## **DLIG Recommendation to VDOT / Loudoun County / Fairfax County for design considerations along US 50 from Route 28 to Poland Road**

DULLES LOOP HIGHWAY PLAN

TYPICAL SECTIONS  
 US 50

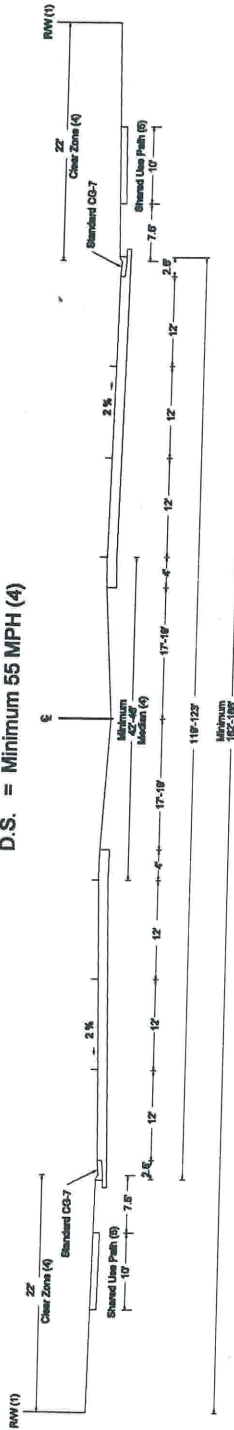
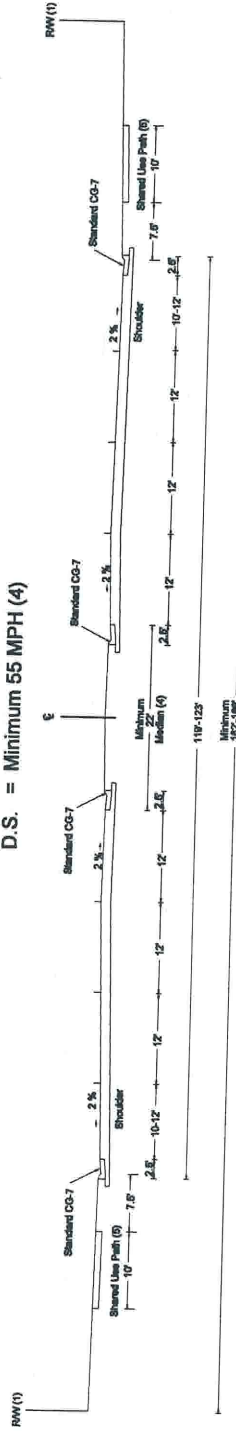
- 1) Preserve the maximum median possible for US 50 that provides ample space for the conversion of the corridor to an uninterrupted flow facility.

As an example: For a 55mph design speed, a minimum median width of 42 to 46 feet for the intermediate-term design of the 6-lane arterial street would allow for conversion of the corridor to free-flow status by reducing the median width, shifting the travel lanes inward to provide for an outside shoulder between the curb and gutter and outside travel lane. A higher design speed will require a greater median width and clear zones. The outside curb and gutter and storm drain system may not be impacted if the shoulders are accounted for in the intermediate design. (Please see the attached figure for illustration of the conversion of US 50 from the intermediate-term design to the long-term design).
